Amendment 31

SUBJECT: AMENDMENT REQUEST TO REDUCE RADON BARRIER THICKNESS AT
AMBROSIA LAKE SITE

TECHNICAL EVALUATION REPORT

FACILITY: Ambrosia Lake

QUIVIRA MINING COMPANY AMBROSIA LAKE TAILINGS DISPOSAL AREA
(FROM AUGUST 2, 1994, SUBMITTAL)

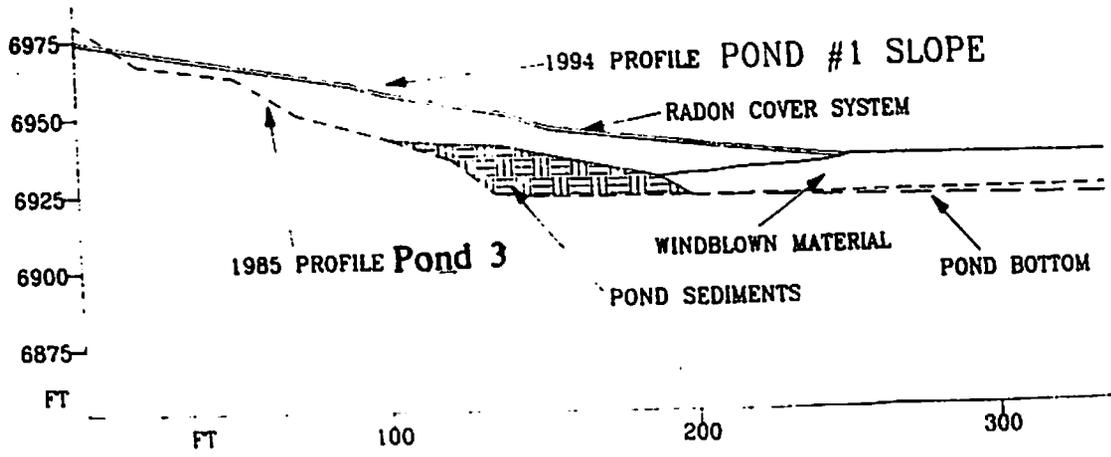
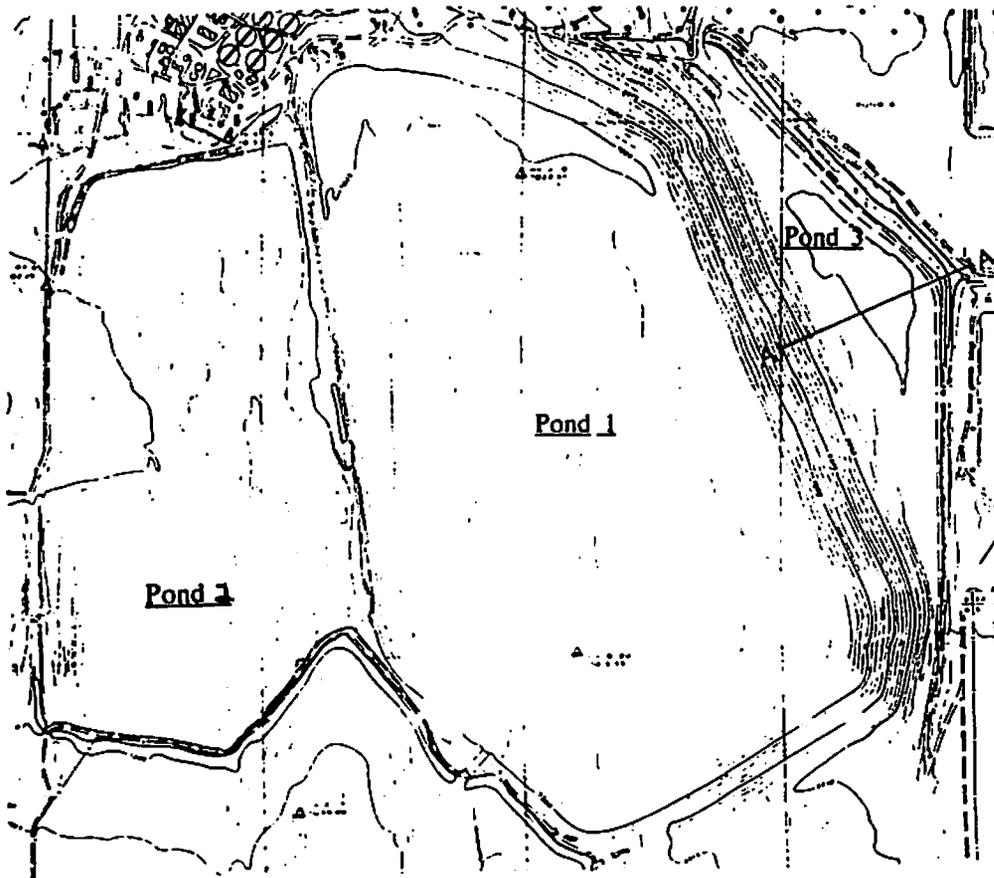
Quivira proposes a radon barrier composed of layers of Mancos shale alternating with layers of SM-SC-CL material. The layer sequence and thicknesses vary for eight areas of the tailings impoundment, based primarily on the type and depth of underlying contaminated material (Attachment B).

The proposed barrier design is supported by RADON computer code analysis for each of the two areas of Impoundment 1 (sands and slimes), the five areas of Impoundment 2 (based on the thickness of the slimes layer), and two areas of Pond 3 (windblown and covered by the east slope of Impoundment 1). The barrier design and acreage of the various areas are indicated in Attachment B.

Quivira's flux models (August 2, 1994) for the portion of Pond 3 covered by the east slope of Impoundment 1, and the windblown portion, reflect the as-built layer sequence and thicknesses (Attachments A and B of this report). The radon attenuation model does utilize the projected 1000-year Ra-226 value, as recommended by NRC staff. This projected value is the amount resulting from the decay of both the current Ra-226 and Th-230. The Ra-226 value for pond sediment had previously been 75 pCi/g, while the projected value is 391 pCi/g. Quivira used tailings data for the other input values for the pond sediments. While these values are not representative of the material, the moisture and diffusion coefficient values should be very conservative.
